WOOLGOOLGA TO BALLINA | PACIFIC HIGHWAY UPGRADE SUBMISSIONS / PREFERRED INFRASTRUCTURE REPORT

Chapter 2

November 2013

Figure 2-1: Wells Crossing to Iluka Road route options

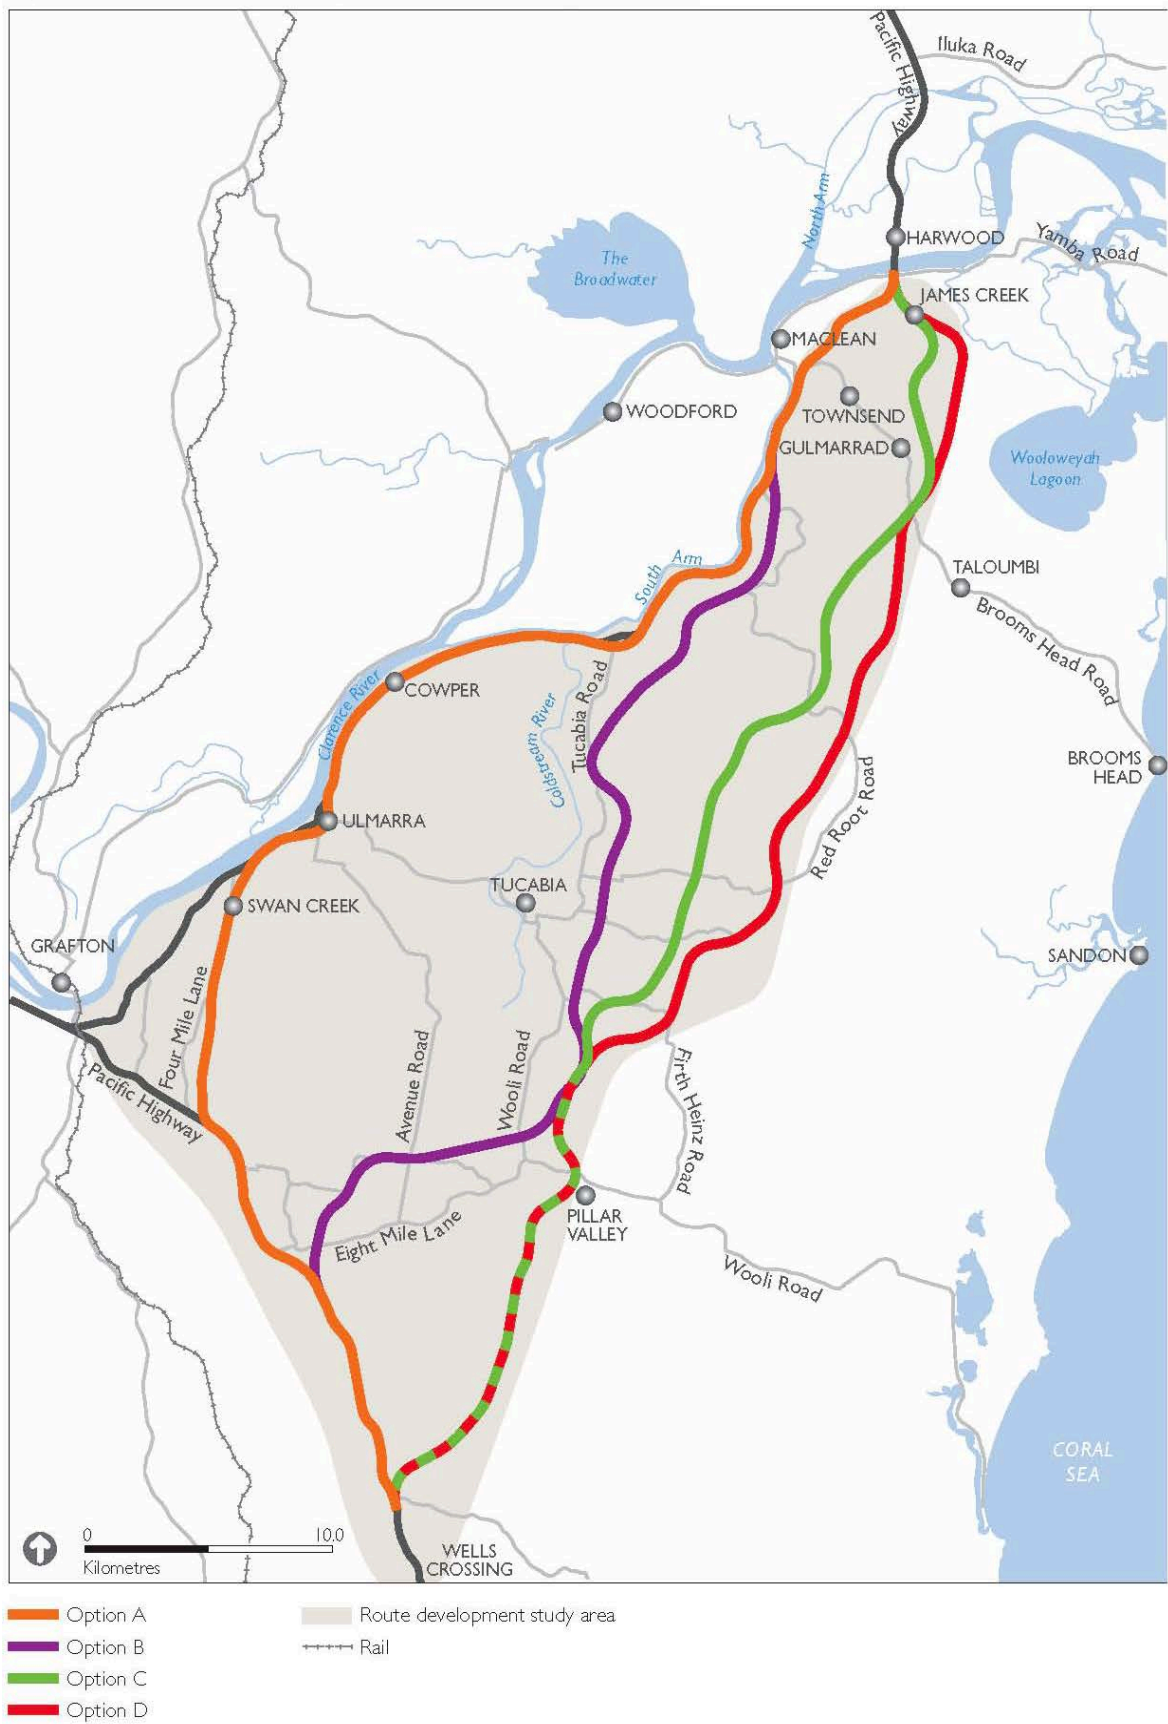
1. Challenged the route alignment between Glenugie and Maclean particularly in relation to the environmental impacts, the cost of the preferred route (including floodplain structures with reference to Kempsey Bridge) and the predicted level of traffic likely to use the upgrade in this section. The orange route should have been chosen.
2. Questioned why the highway isn't being upgraded along the Summerland Way to Casino which, if continued through Kyogle, Woodenbong, and Beaudesert, is by far and away the shortest route to Brisbane?
3. The route between Glenugie and Maclean should be located further east to keep the route shorter.

Possible alignments were identified through preliminary investigations within the study area, mapping of constraints and through the application of the Pacific Highway Upgrade program design standards. These alignments were reviewed in performance against social, environmental and design criteria. Options suggested by the community were also considered. Between Wells Crossing and Harwood Bridge, four short listed route options were identified from the long list of possible route corridors. These were known as the orange (A), purple (B), green (C) and red (D) options (refer to Figure 2-1).

The red option is the most eastern of the short listed options. It deviates from the existing highway just north of Wells Crossing before following a northerly alignment along the eastern side of the study area to the Clarence River at Harwood Bridge. This option passes to the east of Pillar Valley and the Pine Brush State Forest.

More details and comparison of the options including the preferred option are provided in Chapter 4 of the EIS. A comparative assessment of the environmental constraints of the route options of the previous development projects (including Wells Crossing to Iluka Road project) is provided in Appendix I of this report.

Figure 2-3: Woodburn to Ballina route options

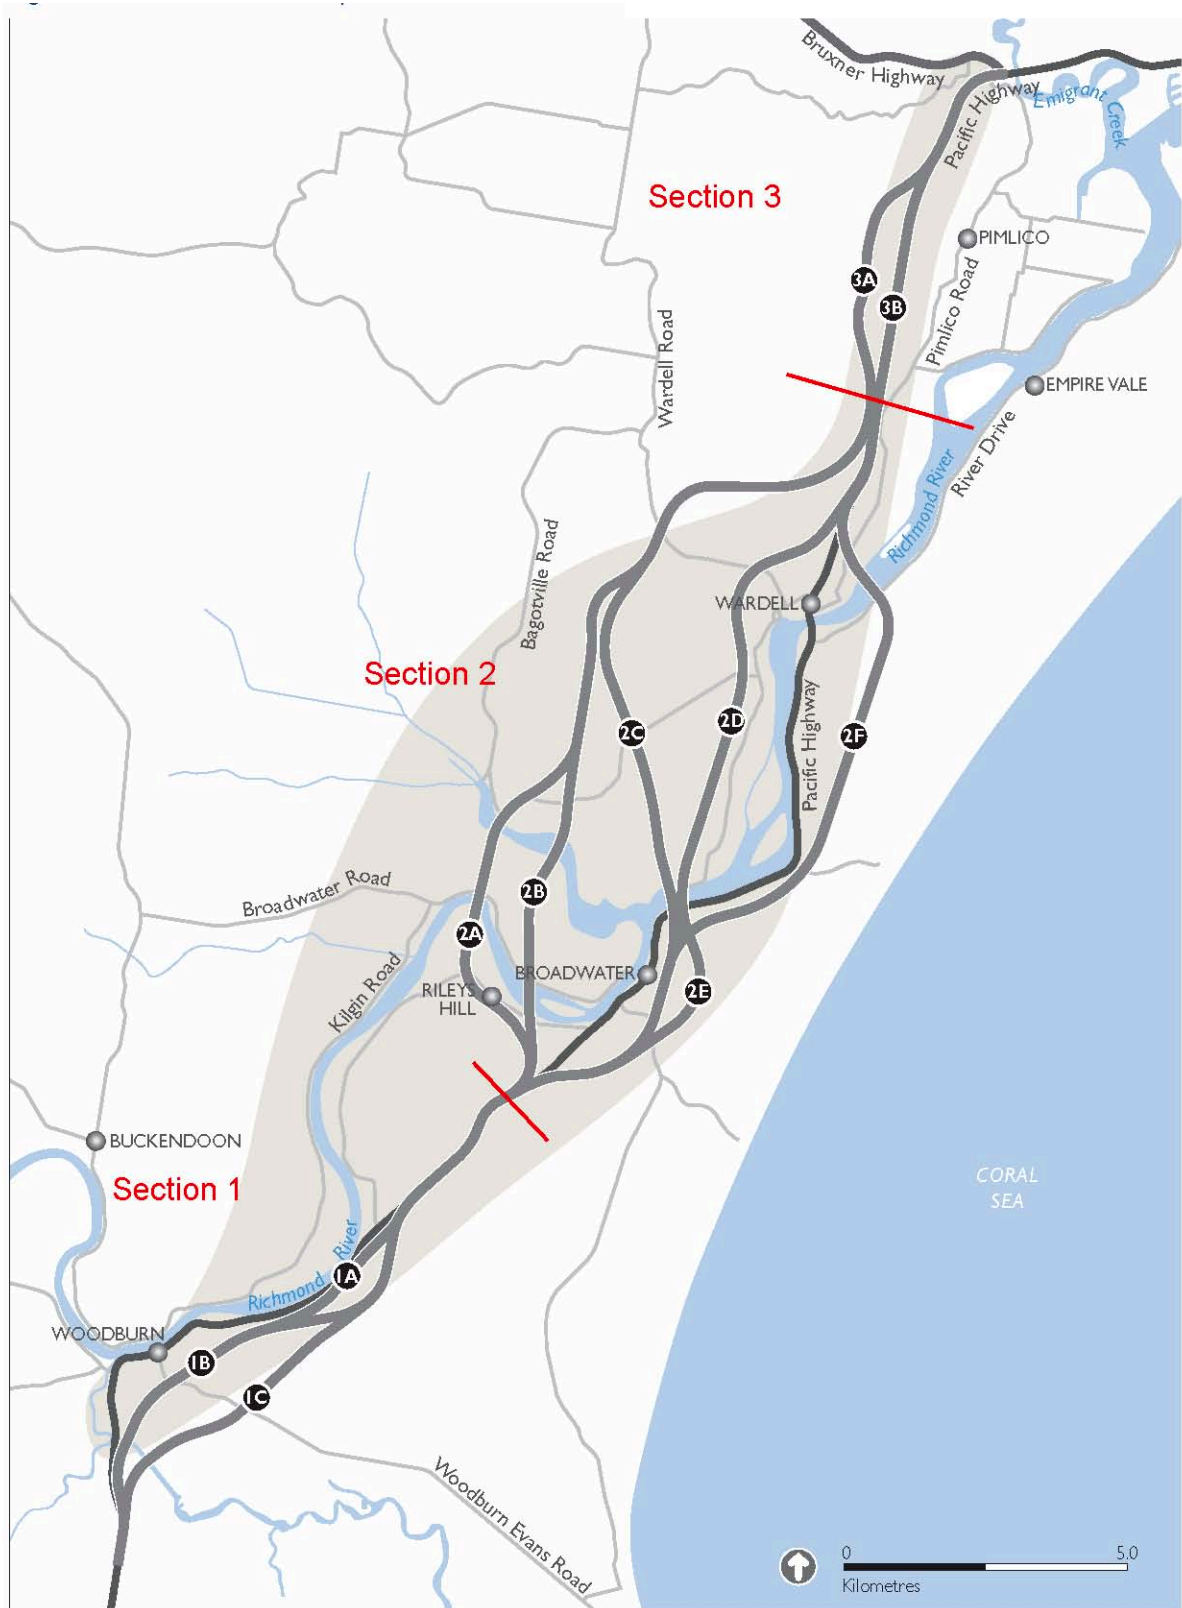
1. The highway upgrade objectives would not be achieved by the Woodburn to Ballina section of the project:
 - Reduced road crashes and incidents.
 - Reduced travel times.
 - Reduced freight transport costs.
 - Provide a route that involves the community and considers their interests.
 - Provide a route that supports economic development.
 - Provide best value for money.
 - Achieve a balance between the environmental, social and economic impacts and benefits.
2. The project will not be able to mitigate all environmental impacts.

A comprehensive route options and selection process was undertaken to identify the preferred route between Broadwater and Coolgardie. This section was developed as part of the Woodburn to Ballina route project (incorporating current project sections 8, 9, 10 and 11). Route options identified between Woodburn and Ballina were divided into three sections (Section 1, between

Tuckombil Canal and south of Broadwater; Section 2, between south of Broadwater to north of Wardell; Section 3, between north of Wardell and Ballina bypass).

A range of short listed route options was then identified for each of these three sections (refer to Section 4.2.6 and Figure 2-3 below). The shortlisted route options were put on public display and comments invited from the community. A value management workshop was held in July 2005, to analyse each of the route options against the following five key criteria: environment, heritage, functional, social and noise, and business and economic. The route options were analysed and a number of key issues raised that would need to be addressed in further phases of the project. The key recommendations from the workshop were:
